DEVIATION REVIEW AND DECISION FORM

**Deviation No. 1
REV 3-14-19**

Subdivision or Project Name: Rollin' Ridge

Section of ECM from Which Deviation is Sought: 2.3.2 Design Standards by Functional Classification

Cherry Crossing Drive Intersection Spacing

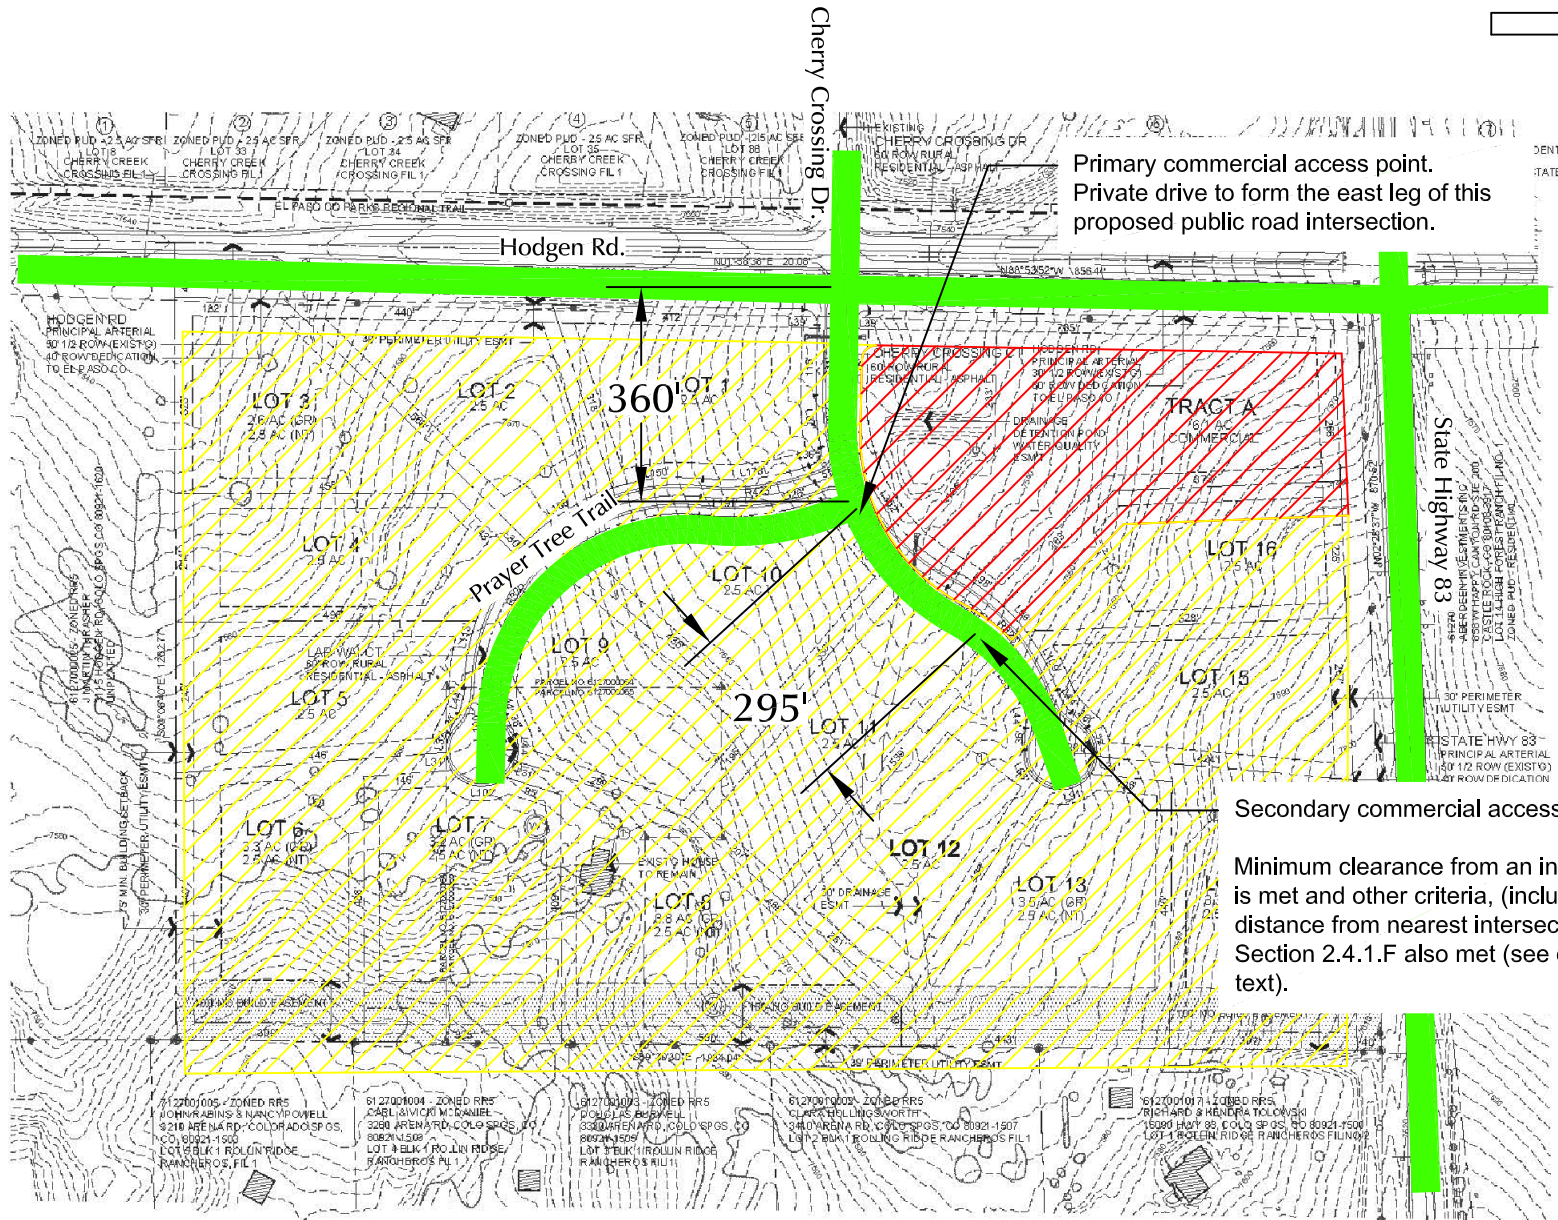
Intersection spacing is not part of this deviation. This exhibit is not necessary for this deviation request.

Minimum clearance from an intersection is met and other criteria, (including site distance from nearest intersection) in Section 2.4.1.F also met (see deviation text).
